From: Gilmore, Tyler J [Tyler.Gilmore@pnnl.gov]
Sent: Monday, March 03, 2014 2:09 PM
To: Roy, Stephen
Cc: Greenhagen, Andrew; Bayer, MaryRose; Smith, Robert H; Akhavan, Maryam; Deniz (Inci) Demirkanli; McDonald, Jeffrey; Williams, Mark D
Subject: Re: AoR delineation
Attachments: 2014-DCL-PredSurfDef-SPILW-002_03-03.jpg

From: McDonald, Jeffrey [mcdonald.jeffrey@epa.gov]
Sent: Thursday, February 27, 2014 3:33 PM
To: Williams, Mark D
Cc: Gilmore, Tyler J; Greenhagen, Andrew; Bayer, MaryRose
Subject: AoR delineation

Thanks for talking today about the FutureGen Alliance (FGA) project. As we discussed, the issue of how the AoR is defined for this project has been a subject of discussion internally and with PNNL. Some of the issues that have caused us concern are:

Predicted Surface Deformation (m)

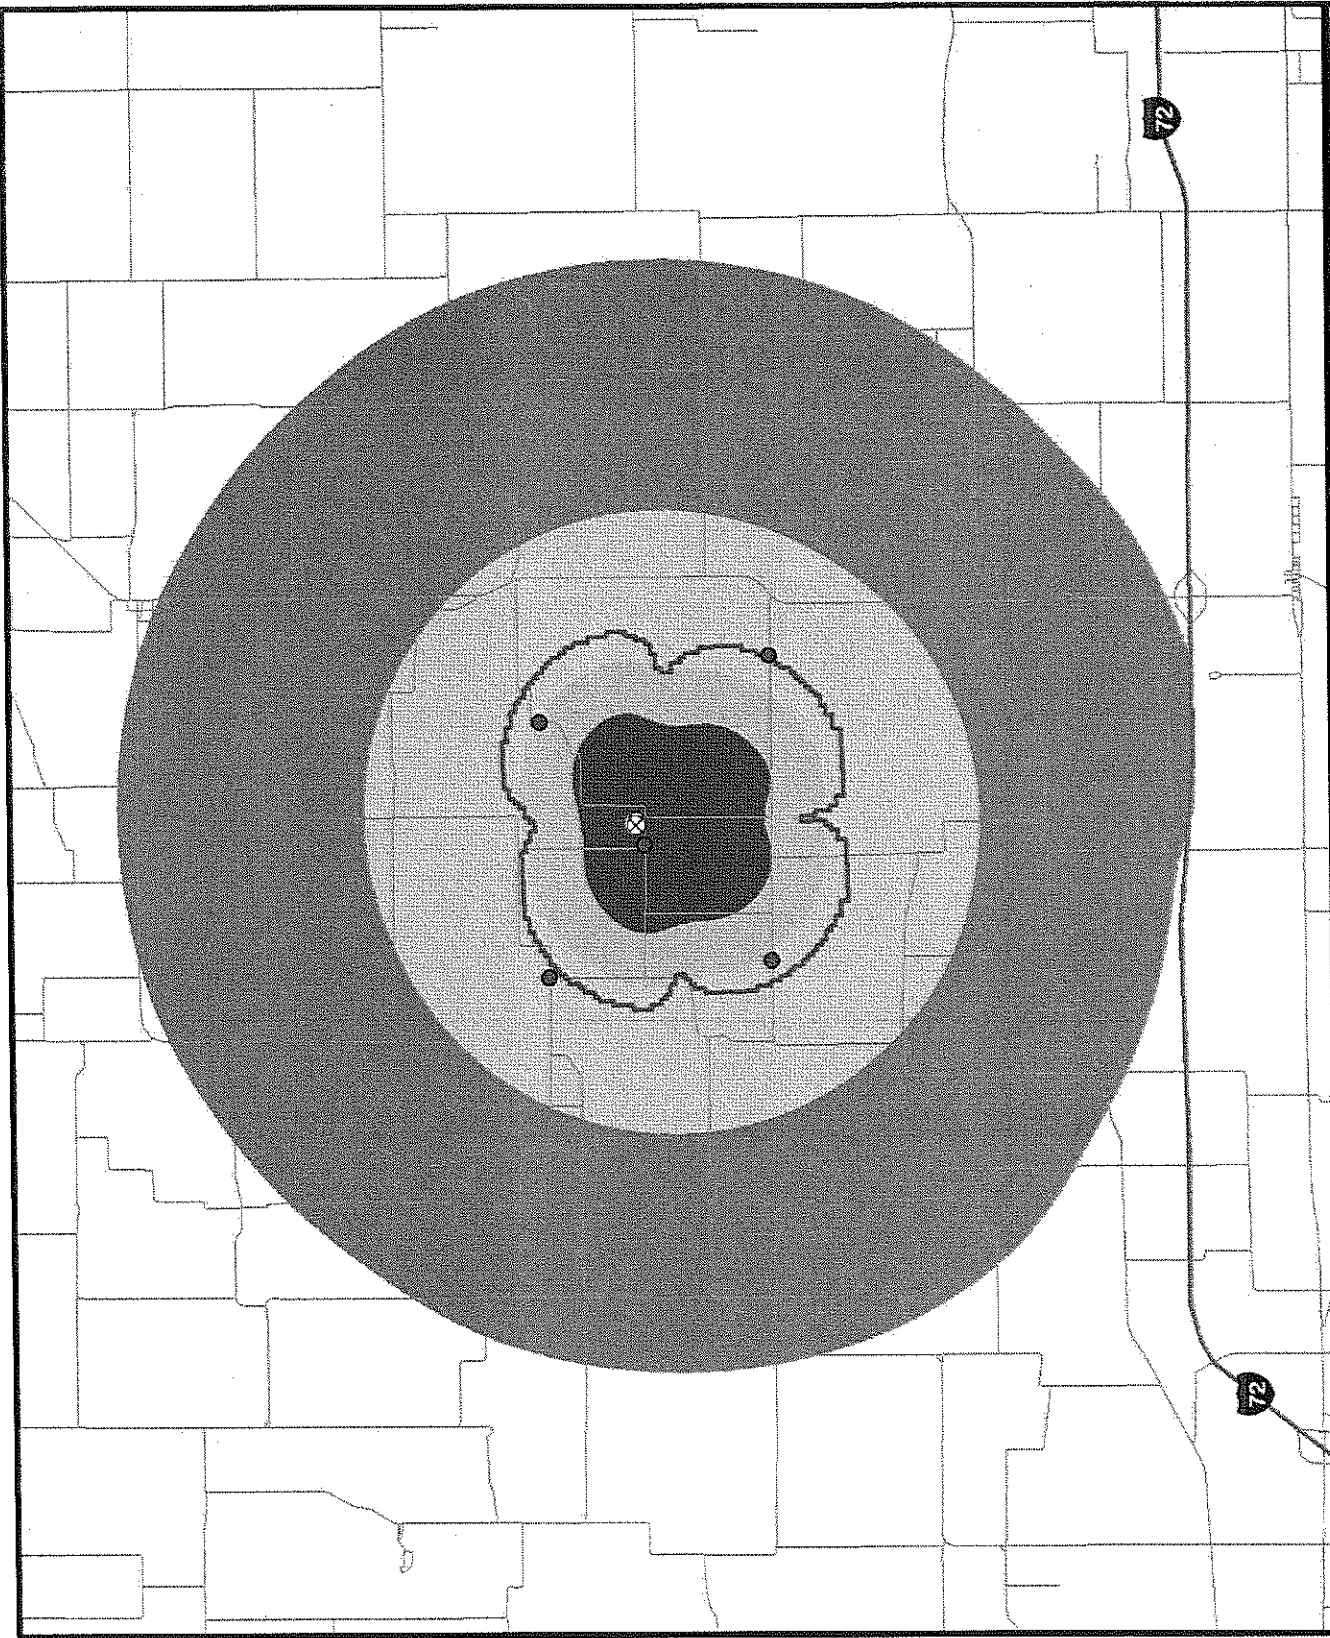
Although using the Nicot method is likely to result in a large AoR, we think that this needs to be considered. I think the FGA/PNNL has looked at this large area already, so we hope this is not too great a burden. We need to talk about how pressure might be monitored in the Mt. Simon, in the near plume and distant areas. We have had some discussions with you and your colleagues on this issue this week and previously. A few of the items that we'd like FGA to provide (by Monday, 3/3/14 ideally) are:

- a complete list of wells that penetrate the confining zone within a Nicot method described AoR. We think this is the maximum extent of the 5 psi contour. That is, where the Mt. Simon might be expected to have 5 psi above the current formation pressure based upon the proposed injection when the contour is furthest from the project location.
- an expanded list of all the monitoring wells with their predicted pressure profiles (injection and post injection phases)
- details on their DINSAR monitoring
 - how much area are you proposing to monitor?
 - how sensitive this is to changes in pressure. Specifically, can you overlay changes in pressure with changes in surface deformation?
- Details on how far outside the plume the passive seismic monitoring can "see" and what resolution you expect with increasing distance.

The pressure deformation map

We would like to discuss how we could satisfy the regulations by monitoring for pressure and as you alluded to in your message we will be measuring indicators of pressure beyond the area of the separate phase CO2 front with the deformation and microseismic approaches. We would like to understand if more is needed.
